Remarks/Arguments

In the response to the Office Action dated September 16, 2005, in the second paragraph, applicants noted that the objections to the drawings under 37 CFR § 1.83(a) and the claims under 35 USC § 112 in Paragraphs 1-5 of the Office Action have been fully addressed in a petition to the Commissioner accompanying the September 16th response. In Paragraph 4 of the Office Action, Claims 1-5, 7, 9, 10, 14 and 15 were rejected under 35 USC § 112, first paragraph, as failing to comply with the enablement requirement. The Examiner asserted that the claims contain subject matter which was not described in the specification in such a way as to enable one skilled in the art to which it pertains, or with which it is most nearly connected, to make and/or use the invention. More particularly, the Examiner asserted that the disclosure and claims refer to a relative difference in size of the fuel element contact area, between the contact area of the “first set of dimples and/or springs” versus the contact area of the “second set of dimples and/or springs”. In this regard, the Examiner asserted:

FIG. 6

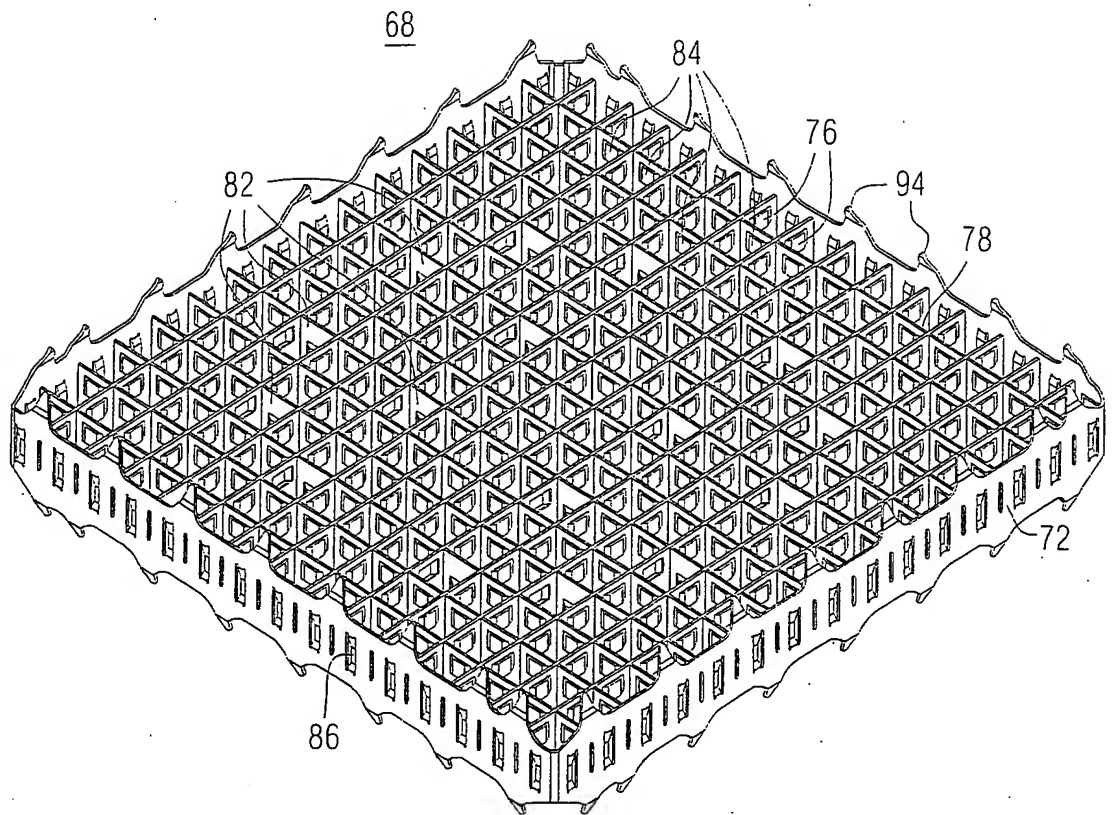
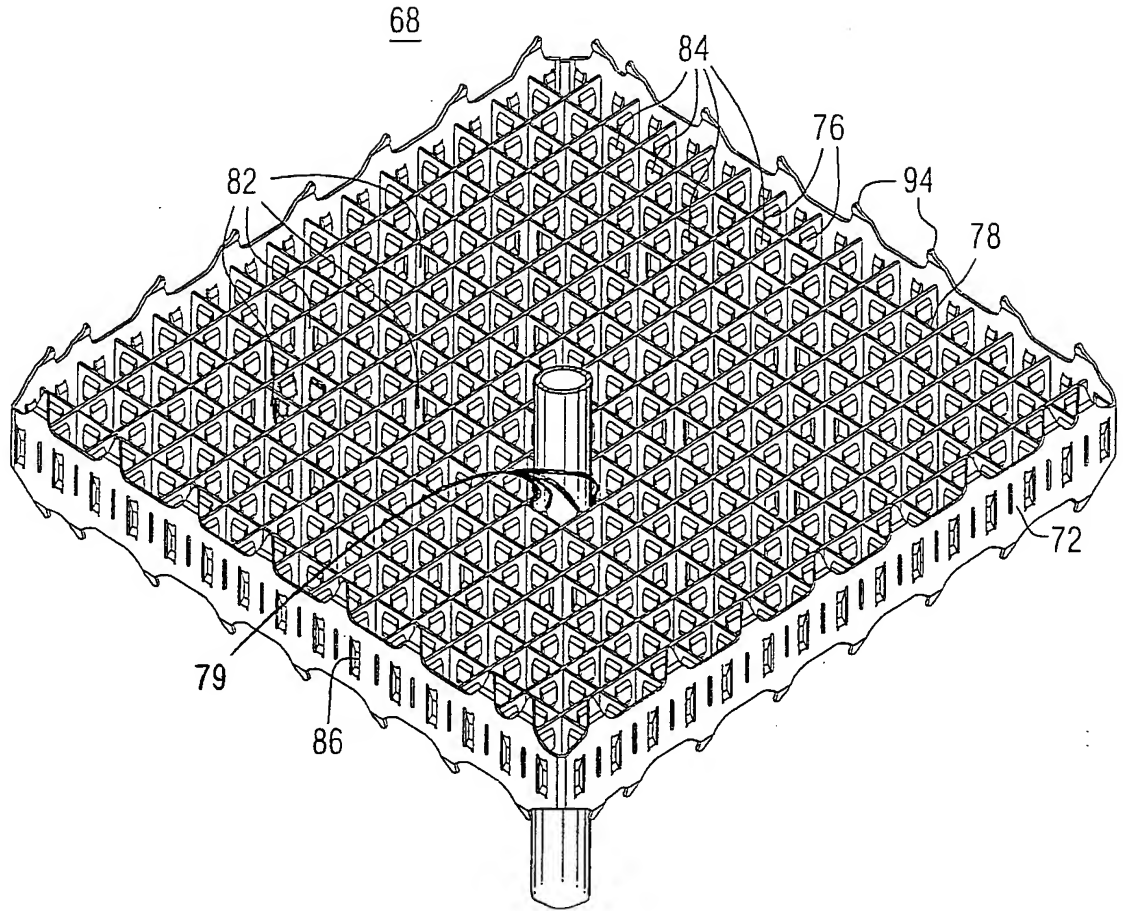
It is immaterial as to whether Fig. 6 shows the outer strap of the auxiliary grid as having vertical springs because the claimed relative difference in contact area of the dimples and/or springs, is with the inner straps of the two different grids (e.g. see the specification on page 11 lines 29+).

Despite applicants arguments to the contrary, it is not seen wherein Fig. 6 shows both vertical springs and dimples on the inner straps nor does it show a common plane intersecting both the vertical springs and the dimples.

Amended Fig. 6 does not clearly show a guide tube attached at the cell corners by butt-welds (it is not known what the slightly darkened portions at the two illustrated diagonal corners of the cell (through which the guide tube passes) is supposed to represent).

While applicants Fig. 6 shows vertical springs on the outer strap of the auxiliary grid, it does not show vertical springs on the inner strap (the inner strap only shows a horizontal dimple at the upper end of the cell wall).

Despite applicants arguments to the contrary, it is not seen wherein Fig. 6 shows both vertical springs and dimples on the inner straps nor does it show a common plane intersecting both the vertical springs and the dimples.

Claim 9 calls for the fuel assembly of Claim 8 wherein the dimples and/or springs on the walls of the respective auxiliary grid support cells are co-planar. Referring to Figure 6, it can clearly be seen that a common plane intersects both the vertical springs and the dimples, which is not the case in the main support grid design.

Claim 13 recites that the auxiliary grid is mechanically or metallurgically affixed to at least some of the guide tubes. The amended Figure 6 clearly shows the guide tube through an auxiliary grid attached at the cell corners by butt-welds. Accordingly, amended Claim 6 should cure the Examiner's objections to the drawings.

In a response mailed February 22, 2005, applicants amended Fig. 6 (attached hereto as Exhibit C) showing the welds attaching the control rod guide tubes to the grid cell in a more pronounced fashion and labeling them with reference character 79. Reference character 79 was also added to the corresponding description in the paragraph spanning pages 11 and 12. Fig. 6 was also amended to better show that the springs in the grid cells that have springs, i.e., fuel rod support cells, are co-planar and are oriented in the vertical direction. Support for both of these changes can be found on page 11 of the specification. The specification was additionally amended to correct the reference to Figs. 4 and 6 in the paragraph beginning on page 9, line 24. It should be clear from the figures that Fig. 6 illustrates a 15x15 array and Fig. 4 shows a 17x17 array. In the Remarks/Arguments section of the response of February 22nd, applicants identified that they disagreed with the Examiner that the drawings did not show the relative size of the contact areas of the dimples and/or springs of the auxiliary support cells versus the main support cells, and that the features of Claims 9 and 13 were not shown. However, for the sake of advancing prosecution, applicants have further amended Fig. 6 to clearly show that the dimples and/or springs are on the vertical and they are all within the same plane. Applicants directed the Examiner’s attention to Fig. 5, which shows the springs of the traditional grid on a diagonal with the contact area shown relative to the width of the cell as being substantially less than that shown for the vertical springs and dimples shown in Fig. 6 relative to the cell wall width illustrated in Fig. 6. In support of this proposition, applicants cited the Federal Circuit opinion in *Hockerson-Halberstadt Inc. vs Avia Group International, Inc.* (222 F.3d 951, 956, and 55 USPQ F.2d 1487, 1491, Federal Circuit 2000) which stated: “It is well established that patent drawings do not define the precise proportions of the elements and may not be relied on to show particular sizes if

Applicants are at a loss as to what the Examiner is referring to, because the amendment provided to Fig. 6 in Exhibit D, which accompanied applicants' Request for Continued Examination, clearly shows the springs and/or dimples on the inner straps in a vertical orientation, all on the same plane. 37 CFR § 1.83(a) provides:

It is respectfully asserted that applicants have complied with this requirement. In Paragraph 2 of the Office Action, the Examiner has asserted that Fig. 6 (in Exhibit D) has not been approved as it is drawn to new matter. It is respectfully asserted that the amendments to Fig. 6 were merely made to conform the drawings to the description in the specification as quoted above. Therefore, the same should not be considered new matter.
